May 23, 2023

**SUBJECT: MERGE 56 - UNIT 10: LOTS 1, 2, 3, 4, 5 & 6, UNIT 4: LOTS 3 & 4 – PDP #2
(PRJ-1059203)
ADDENDUM LETTER TO MERGE 56 ONSITE UNIT 1 AND 2 STORM WATER
QUALITY MANAGEMENT PLAN**

This letter is to address the proposed changes to the previously approved Merge 56 Unit 1 (PTS #697235) and Unit 2 (PTS #697236) Construction Change 'B' Storm Water Quality Management Plan.

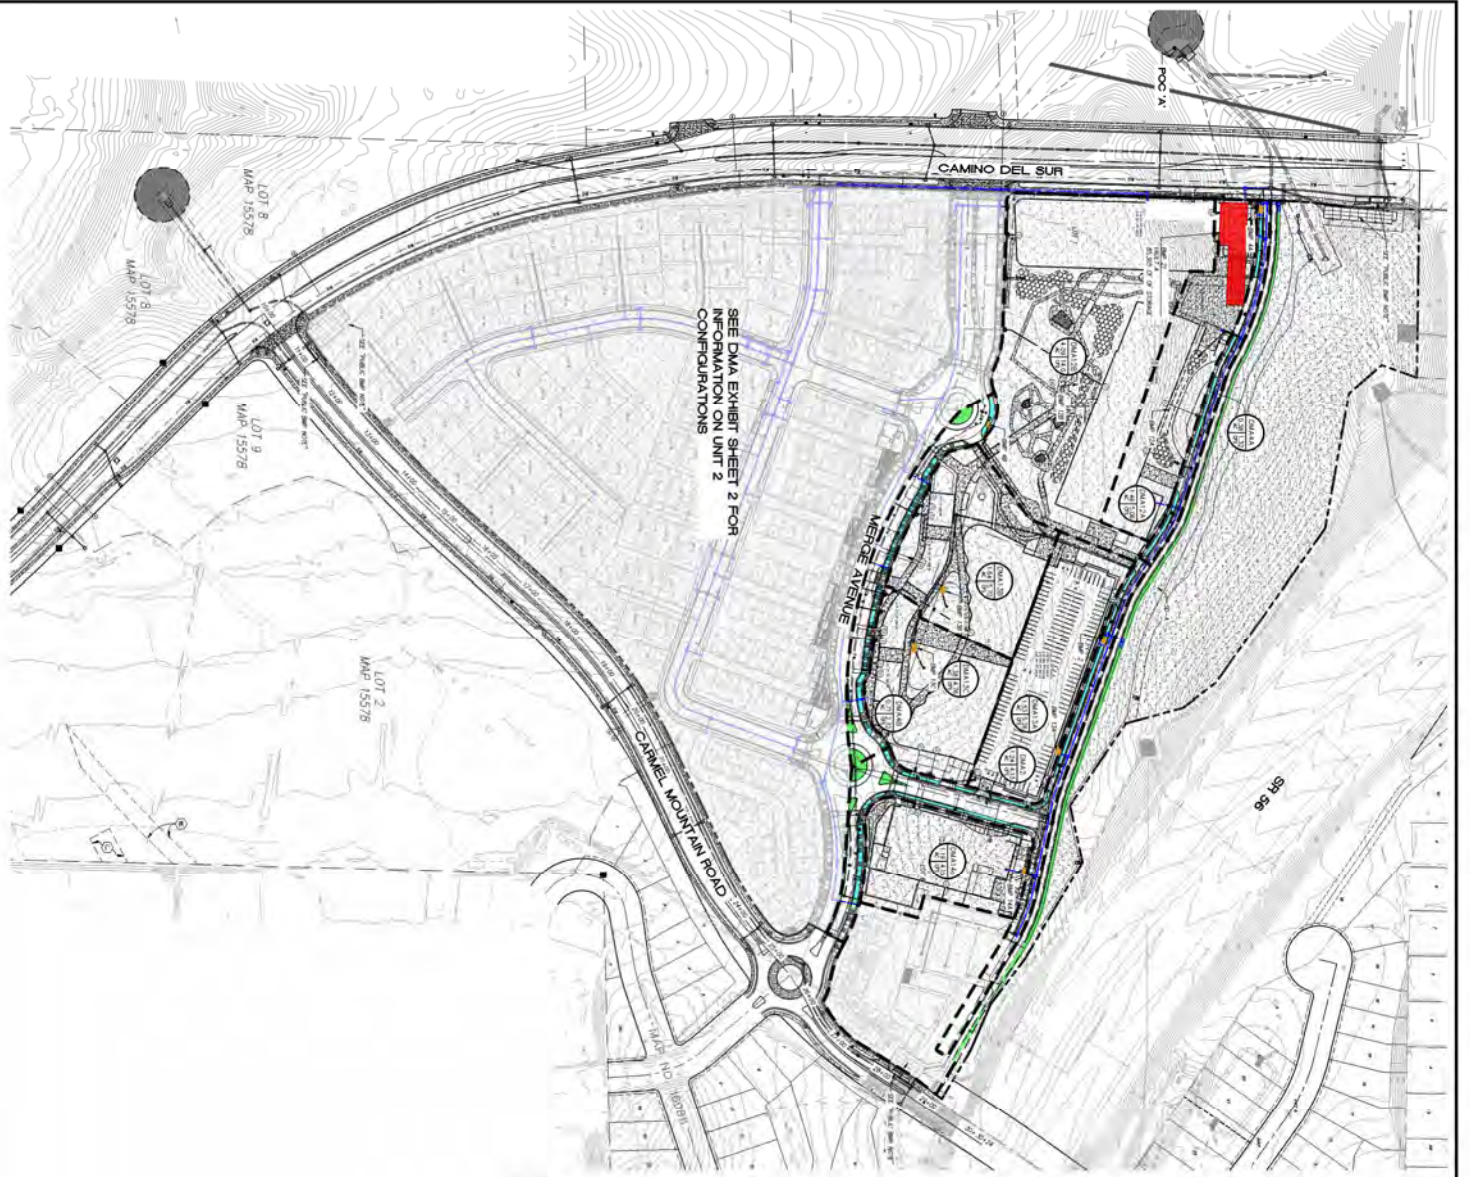
Proposed PDP: The proposed PDP has been designed to maintain overall drainage patterns as the previously approved CC'B', but includes adjustments to DMA boundaries and routing. DMA 12 will now be split into 2 DMA's, 12a and 12b with a system of biofiltration basins treating each. DMA 13 is being separated into 3 DMA's, 13a, 13b, and 13c, each utilizing an MWS unit for treatment. DMA 14a is remaining the same but will now use an MWS unit for treatment. Since the PDP proposes to remove Private Drive R, DMA 4 will be split into 4a and 4b to treat Private Drive T and Private Drive M, respectively. Since a MWS unit has already been installed for the previous DMA 4, DMA

4a will utilize the same unit. DMA 4b will utilize a new MWS unit.

Hydromodification of the site will utilize the same storage vault approved in the onsite SWQMP. This PDP amendment does propose to shift and rotate the existing vault to better work with the proposed site plan. Since the previously approved vault was sized conservatively for the full build-out condition, no changes are required to vault sizing as the thresholds for this PDP fall within the thresholds used to size the vault originally.

MWS-L-8-12-6'-0"-V-UG
STORMWATER BIOFILTRATION SYSTEM
STANDARD DETAIL

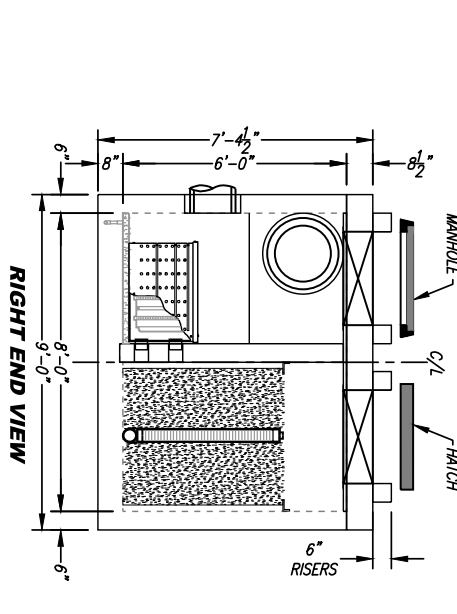
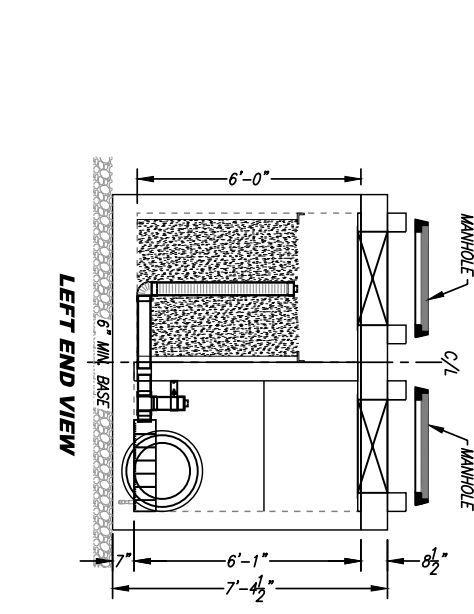
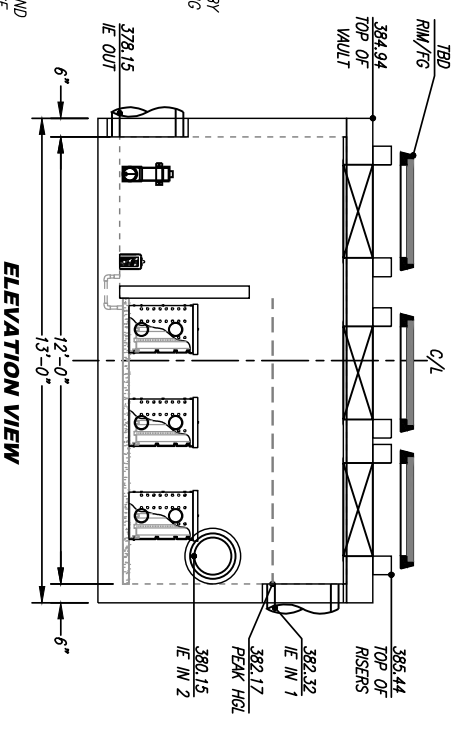
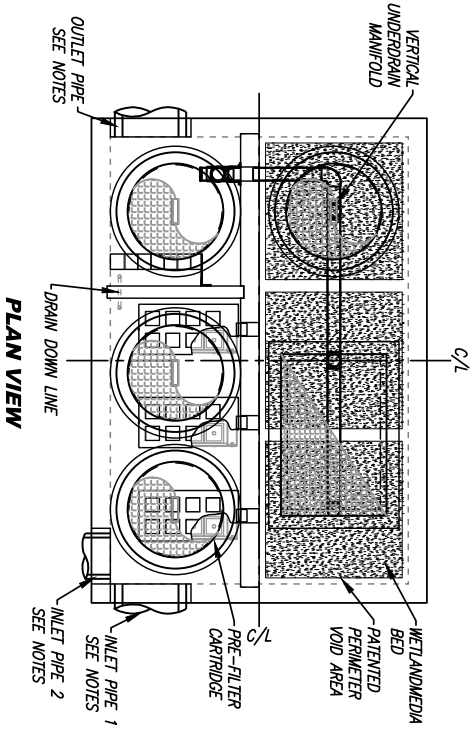
NOTES: PRELIMINARY NOT FOR CONSTRUCTION. INLET PIPE 1 LOWERED TO FIT BELOW SOFT OF VAULT. ENGINEER TO VERIFY FOUR CORNER RM ELEVATIONS.
